**TENDER NO: 2024-09**

**Lancaster WWTF Aeration System Renewal**

**LANCASTER WWTF AERATION SYSTEM RENEWAL**

**ADDENDUM NO:** 3

**DRAWING TITLE**  
 NEW AERATION LAYOUT

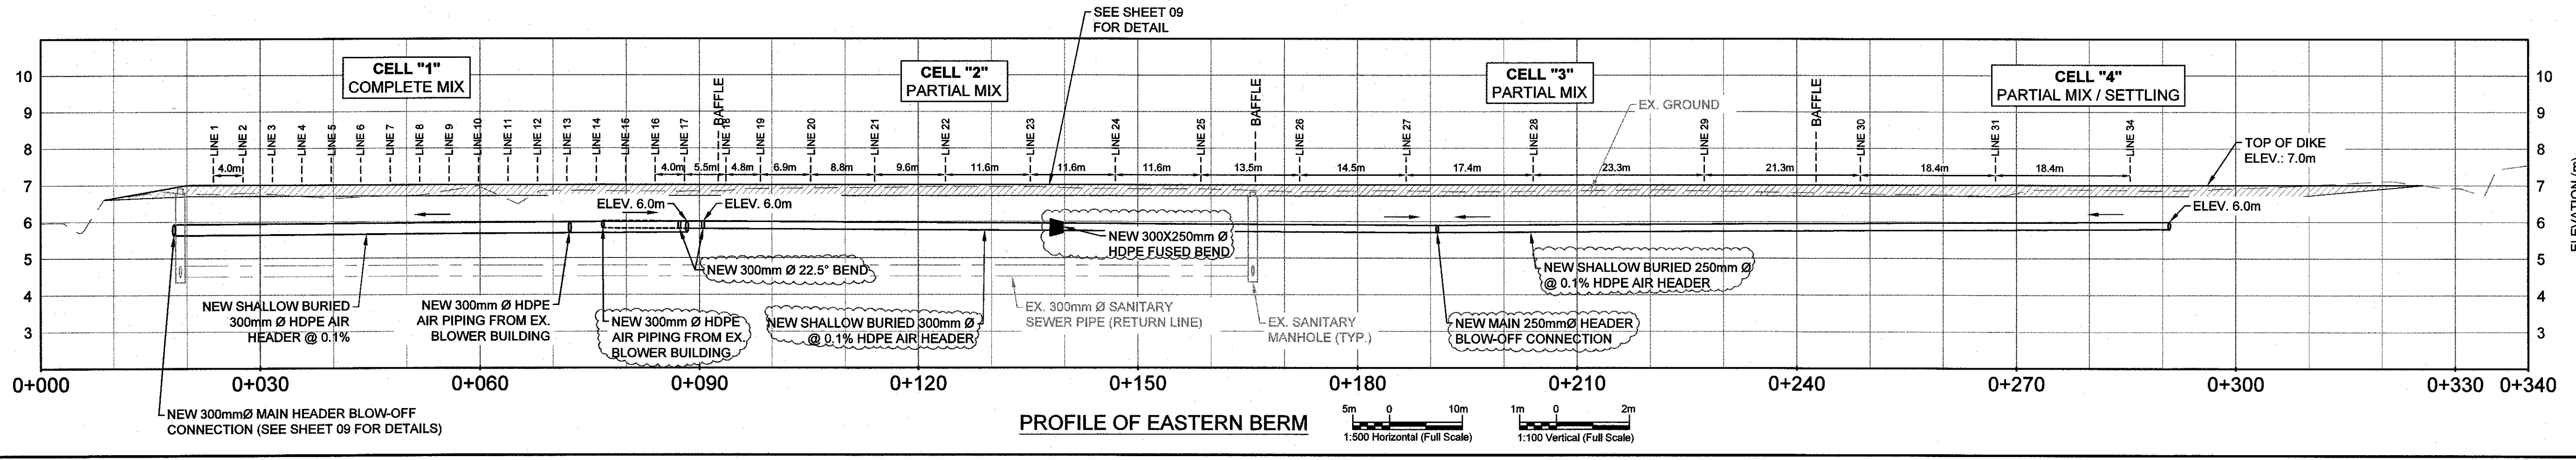
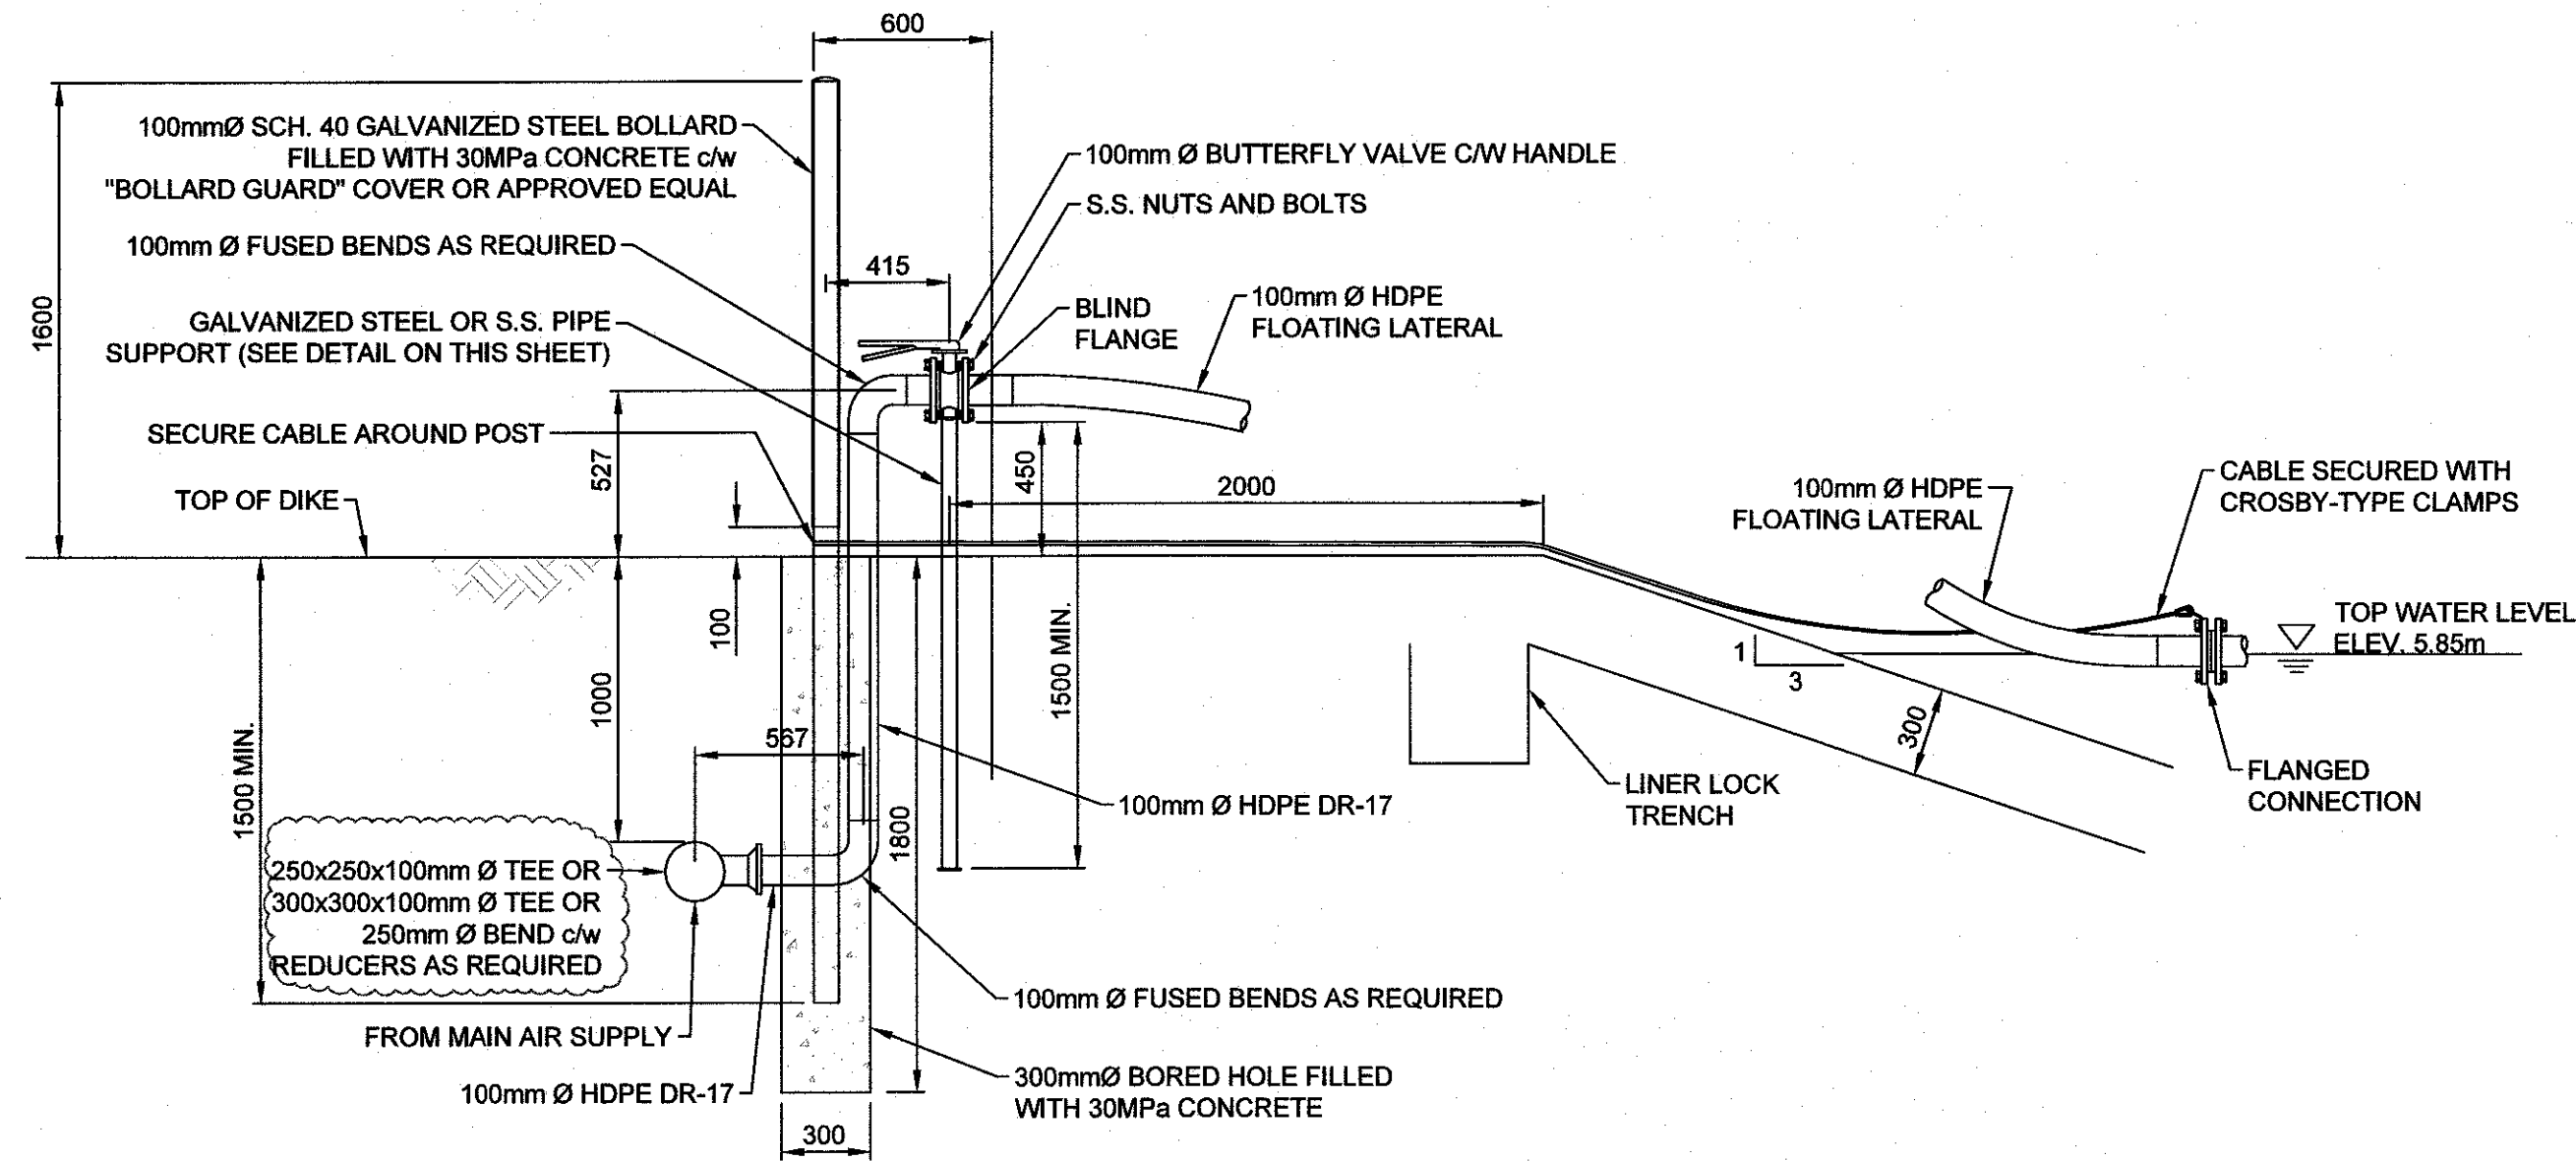
**Q2:** Section 10 81 01, Item 2.5.2 (Page 106) states the aeration system supplier must confirm header sizing as part of the overall design responsibility. The header is being provided by others; the aeration system supplier has reviewed the header sizing and agrees with the 300mm header from the building to cell #1, but recommends the header to cells #2, 3, 4 be increased to 300mm and reduced to 250mm after the sixth lateral in cell #2, instead of the 200mm indicated on the drawing set.

**A2:** Please see attached updated Sheet 8 of 14 and 9 of 14 of the drawing set.
